PROJECT NAME: North West Cambridge Masterplan

SCHEDULE OF APPLICANT'S RESPONSES TO COMMENTS RECEIVED

COMMENTS RECEIVED FROM:	Lead Local Flood Authority (LLFA)	FORMAT:	Email	DATE RECEIVED:	28/10/2025
SUBJECT:	Flood Risk and Surface Water Drainage

NWC-MP2024-ACM-PL-SK-05003

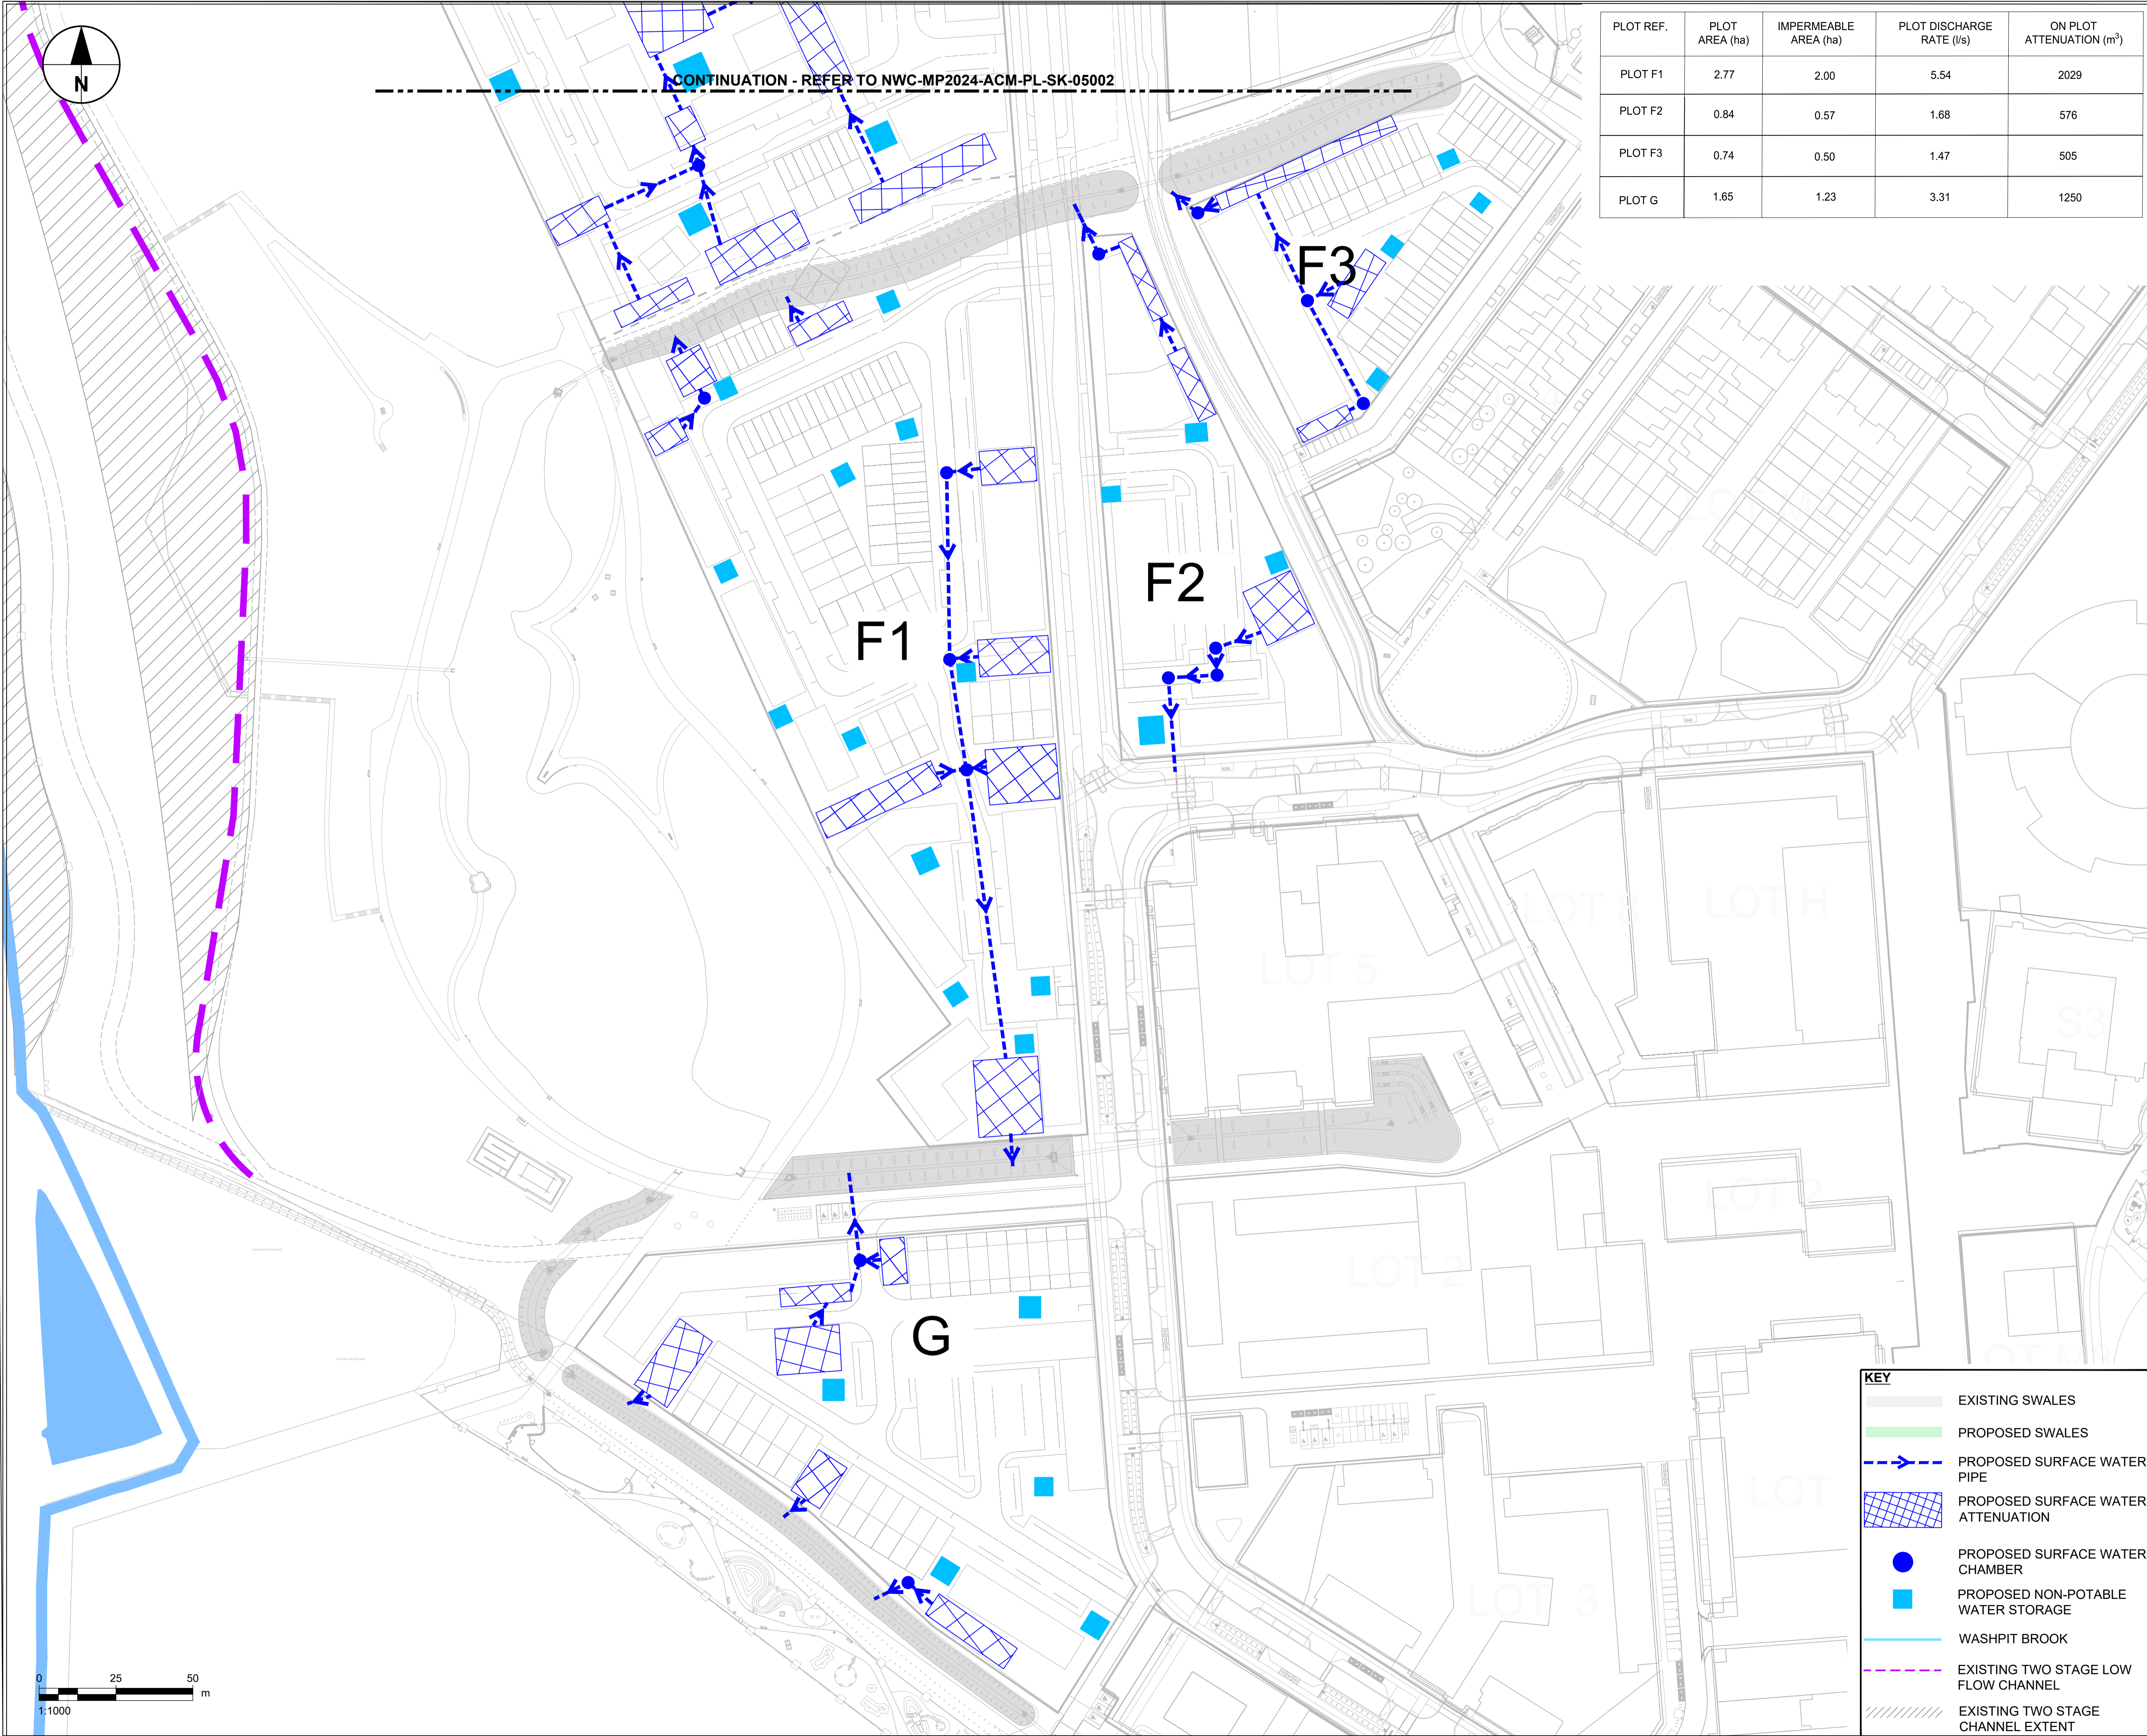
ID	ISSUE	COMMENT	RESPONSE
2.	Impermeable drained area plan	In order for us to accurately assess the proposed scheme, an impermeable drained area plan must be submitted showing an accurate area (hectares) for each plot and the required attenuation for each plot. At present this has not been provided as part of the application.	Drawings NWC-MP2024-ACM-PL-SK-05001 to 05004 submitted as part of the FRA and SWDS includes tables showing the total area and impermeable area for each plot in hectares.

SHEET NUMBER **REV**
 NWC-MP2024-ACM-PL-SK-05004 P02

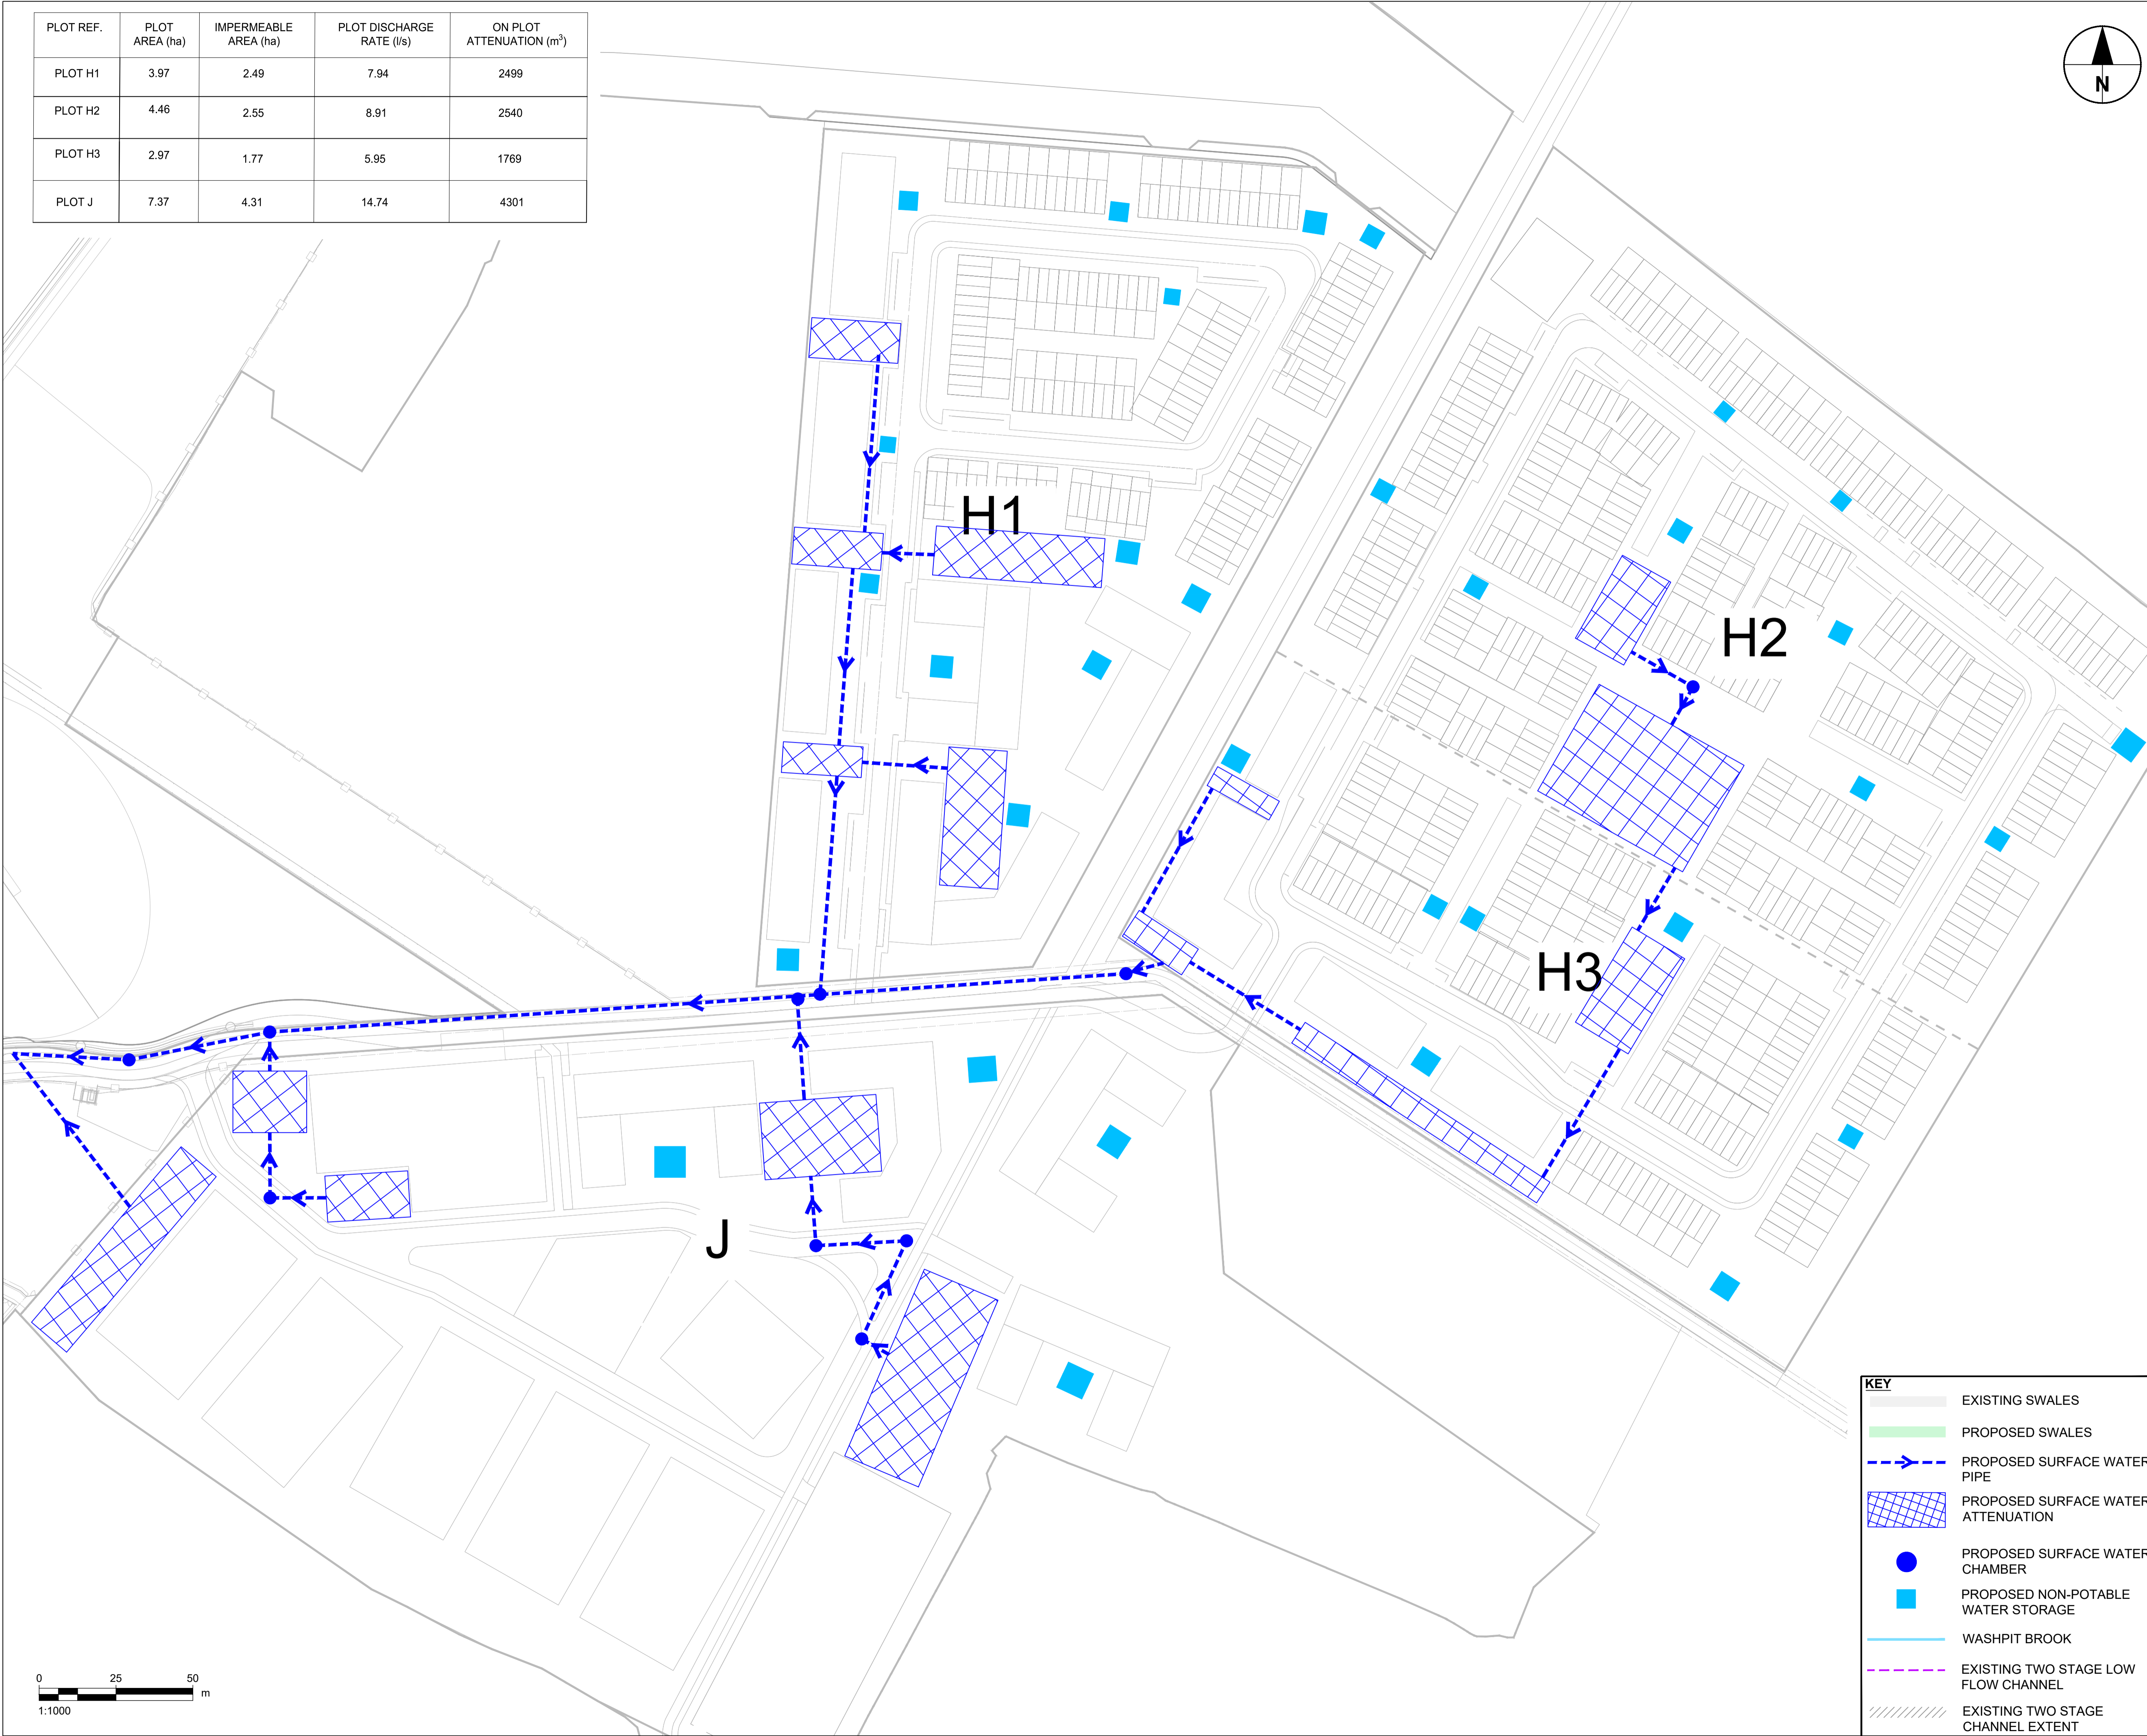
5.	Detached Plots	Plots H1 H2 H3 and J are separated from the main site and proposed surface water discharge points in the northern section of the site by the existing Eddington development. It is not clear from the submitted drainage strategy how surface water from these plots will be managed.	Plots H1 H2 H3 and J will be restricted to 2 l/s/ha and discharge into the Phase 1 existing drainage network as per the previously consented strategy.

Tank (3)

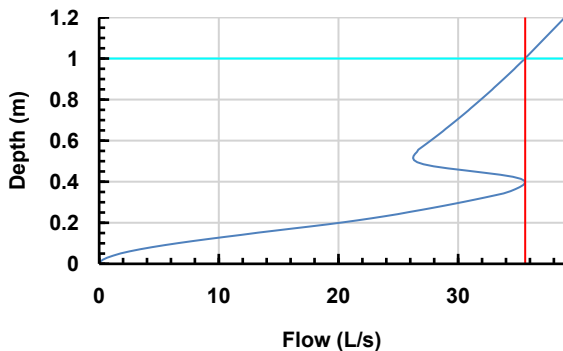
ID	ISSUE	COMMENT	RESPONSE
		<p>other and be clear so we can comment accurately on the proposed scheme.</p> <p>b) The calculations provided for 'tank 3' demonstrate half drain times of 7559 minutes and 8079 minutes for two of the modelled storm scenarios. Half drain time for all elements of the system, particularly those directly prior to flow control, should be less than 24 hours (1440 minutes) in order to ensure that the system has the capacity to accommodate rainfall events occurring in quick succession.</p> <p>c) Attenuation basins have been modelled with no freeboard. All storage areas for the design must include an appropriate freeboard allowance in accordance with CIRIA SuDS Manual C753.</p> <p>d) The system has been modelled using a figure of 100% porosity, this is not appropriate.</p> <p>e) The modelled dimensions of some swales do not align with guidance, for example, exceeding the maximum side slope or depth, see CCC Surface Water Planning Guidance and CIRIA SuDS Manual C753 for further guidance</p> <p>f) It is noted that oversized attenuation pipes are proposed as an option in the main body of text. This should be clarified. If oversized pipes are proposed, the applicant should clarify why the water cannot be better managed elsewhere within the on-site network using SuDS such as green roofs, swales, and permeable paving.</p> <p>g) Some hydrobrake discharge rates in the calculations appear very high.</p>	<p>b)"Tank 3" was modelled to only represent approximate storage available within the existing phase 1 lagoon to ensure the existing attenuation available within Phase 1 is sufficient to take the discharge from the new OPA development in addition to the phase 1 catchment discharging into the lagoon. Therefore, the half drain times for the tank is not applicable.</p> <p>c) Proposed detention basins are located at lower parts of the site. Proposed plot levels are higher than the top of detention basin level providing freeboard via the difference in the level between the nearest adjacent plots and the top of the basin level. Raised plot levels are minimum c. 500mm above the 100-year +40% cc water level at the proposed detention basins.</p> <p>d) The porosity in the ID model refers to percentage of the attenuation feature that is available for storage. For the basins, these will be dry unless required for storage and therefore, 100% porosity is applied. For "Tank 3", as mentioned these are only to represent the approximate storage available in the existing lagoon and therefore, shown as 100% porosity to just reflect the storage volume.</p> <p>e) Base width, longitudinal and side slopes are in line with the CCC guidance and the CIRIA SuDS Manual C753. Where longitudinal slopes are greater than 3%, check dams will be considered as part of detailed design. Proposed depths of the swales are deeper than the typical depths due to the depth required to allow the surrounding plots to drain by gravity above the base of the swale to slow the runoff and provide treatment. This is in line with the previously consented strategy and the swales constructed as part of the Phase 1 works.</p> <p>f) Oversized pipes have been modelled mainly to demonstrate that they work from technical and hydraulic perspective. The strategy is eventually envisaged to be a combination of the two options to balance the SuDS requirement and space required for landscaping/amenity areas at detailed design stage. On plot SuDS will be considered as part of the detailed plot design at next stage.</p> <p>g) We assume this relates to high discharge rate applied to "Tank 3". The 221 l/s from "Tank 3" is to represent the proposed 1 in 100 year discharge rate from Phase 1 agreed and implemented as per the previous consented strategy. Proposed detention basin part of the OPA are restricted to 2 l/s/ha</p>
